Title - Sujet FLUID COOLER INSTALL	
Solicitation No. - N° de l'invitation 39903-150572/A	Amendment No. - N° modif. 003
Client Reference No. - N° de référence du client CFIA 39903-150572	Date 2015-10-01
GETS Reference No. - N° de référence de SEAG PW-\$PWU-201-10546	
File No. - N° de dossier PWU-5-38075 (201)	CCC No./N° CCC - FMS No./N° VME
Solicitation Closes - L'invitation prend fin at - à 02:00 PM on - le 2015-10-06	Time Zone Fuseau horaire Mountain Daylight Saving Time MDT
F.O.B. - F.A.B. Plant-Usine: <input type="checkbox"/> Destination: <input type="checkbox"/> Other-Autre: <input type="checkbox"/>	
Address Enquiries to: - Adresser toutes questions à: Ho (RPC), Hector	Buyer Id - Id de l'acheteur pwu201
Telephone No. - N° de téléphone (780) 901-0989 ()	FAX No. - N° de FAX (780) 497-3510
Destination - of Goods, Services, and Construction: Destination - des biens, services et construction:

ADDENDUM M-02

Project:	CFIA Dry Cooler	Project No.:	151-05170-00
Date:	September 30, 2015	Client Proj. No.:	H0004
To:	CFIA, Attn: Craig Armitage (craig.armitage@inspection.gc.ca)		
Distribution:	WSP, Attn: Art Johnson (art.johnson@wspgroup.com) WSP, Attn: Sandeep Sharma (sandeep.sharma@wspgro

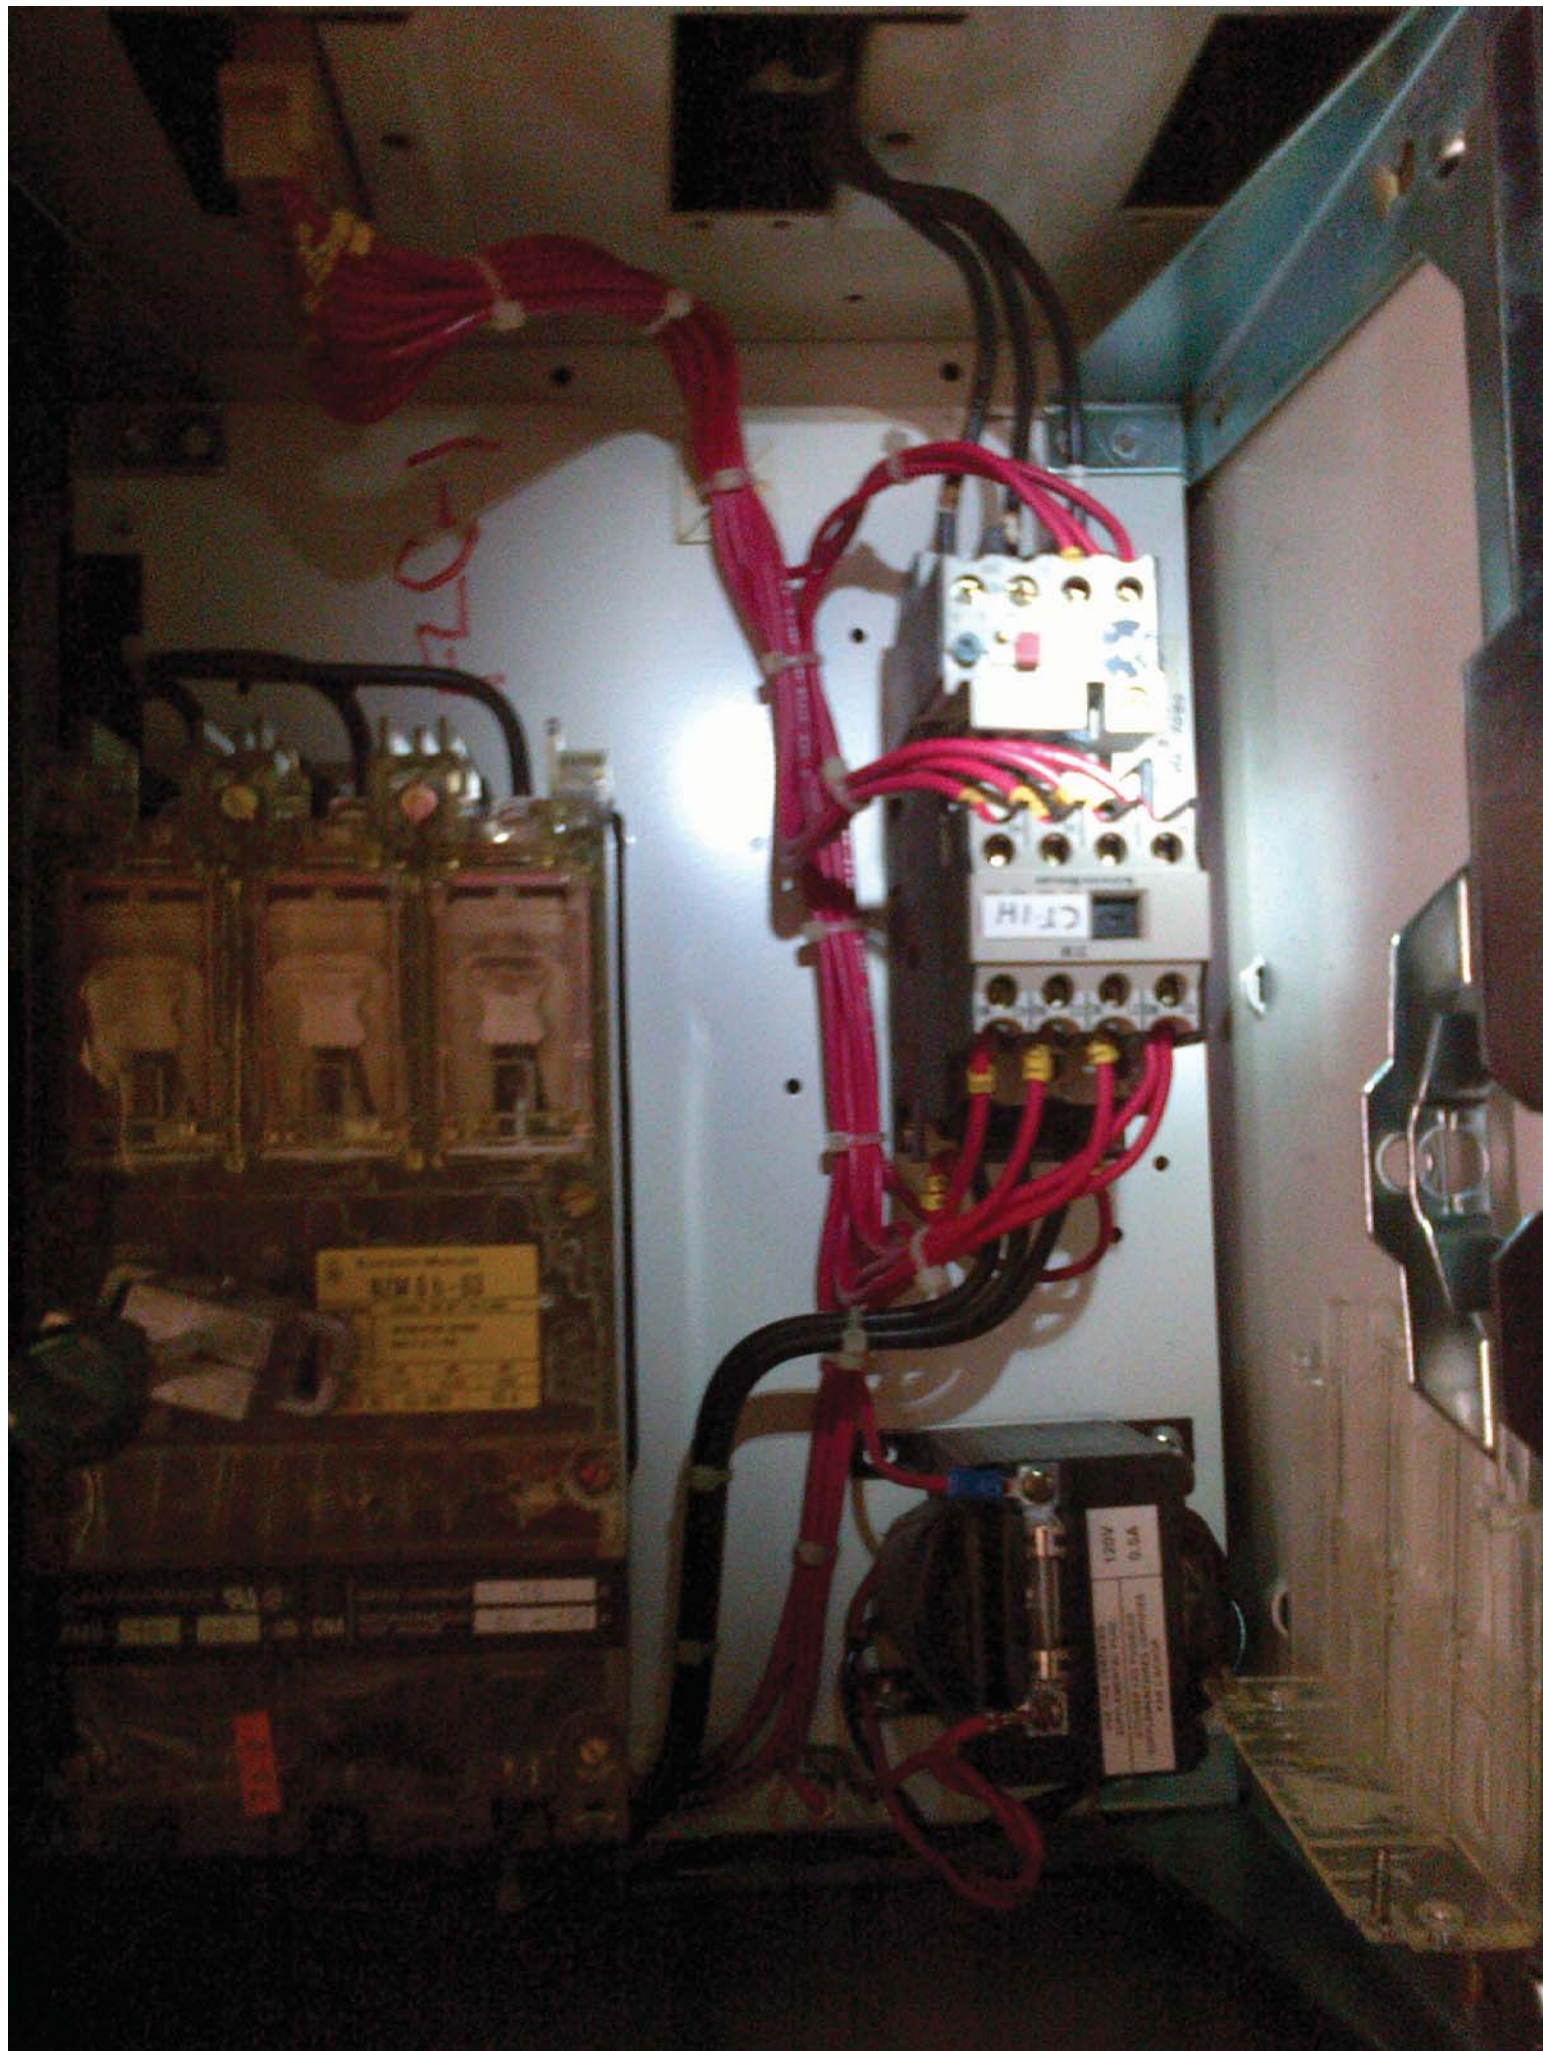
1. Section 23 07 14 "Thermal Insulation for Piping" does not show Fluid Cooler Glycol s & R , Chilled water s & r (CWS CWR) to be insulated, please confirm insulation type and thickness.
2. Could we please get volume of the chilled water system that needs to be drained and re-filled?
3. Please clarify the pipe size on the glycol system. It calls for 80ml Pipe we can only supply 75ml or 100ml

2.1 The volume of chilled water that is required to be drained for piping tie in at connection point M1 is estimated at approximately 20L. The tie in connection to HE-5 is inside of the isolation valves on the heat exchanger side; the amount of drained piping is expected to be minimal assuming proper isolation can be achieved.
